Affected Publication: API Specification 16A, *Specification for Drill-through Equipment*, Fourth Edition, April 2017

Errata 3

API SPECIFICATION 16A
FOURTH EDITION, APRIL 2017

ERRATA 3, MAY 2018
ERRATA 2, NOVEMBER 2017
ERRATA 1, AUGUST 2017
ADDENDUM 1, OCTOBER 2017

Section 5.3.5.2.3, Figure 9c:

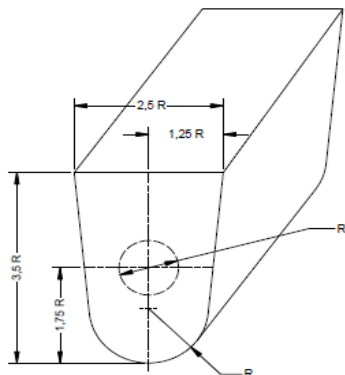
- Insert new right-most figure:
